Final Independent External Peer Review Report Upper Des Plaines River and Tributaries, Illinois and Wisconsin Feasibility Study (Phase II Study)

Prepared by
Battelle Memorial Institute

Prepared for
Department of the Army
U.S. Army Corps of Engineers
Flood Risk Management Planning Center of Expertise
Baltimore District

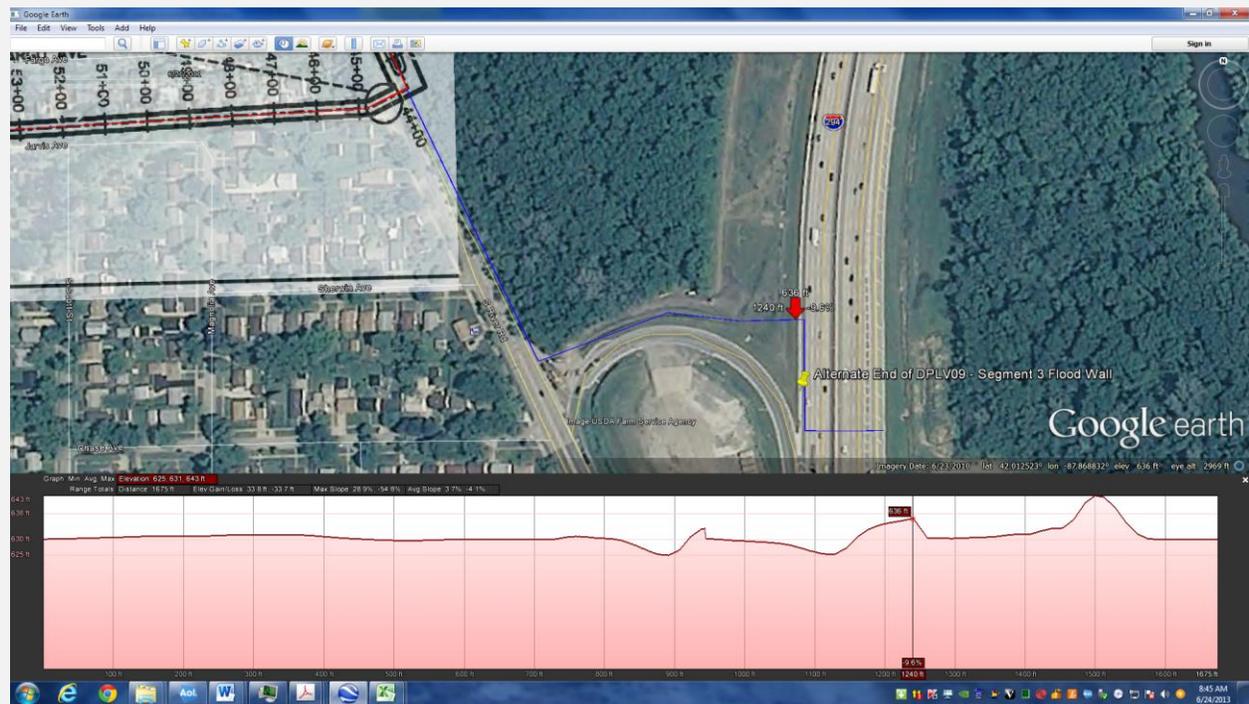
The proper design of a flood damage risk reduction measure should not prevent access to existing commercial and residential driveways and public and private sidewalks from existing streets with flood walls or the raising of road grades.

1. Review the grades along Ashley Street for DPLV09 – Segment 1 flood wall and confirm that all existing commercial and residential driveways and building access walks can be accessed by normal means.
2. Modify the proposed flood damage risk reduction measure at all driveways, sidewalk, and private access walks noted to be inaccessible by normal means to permit normal access.
3. Modify the proposed flood damage risk reduction measures to permit handicapped access at all locations found to be inaccessible to the handicapped
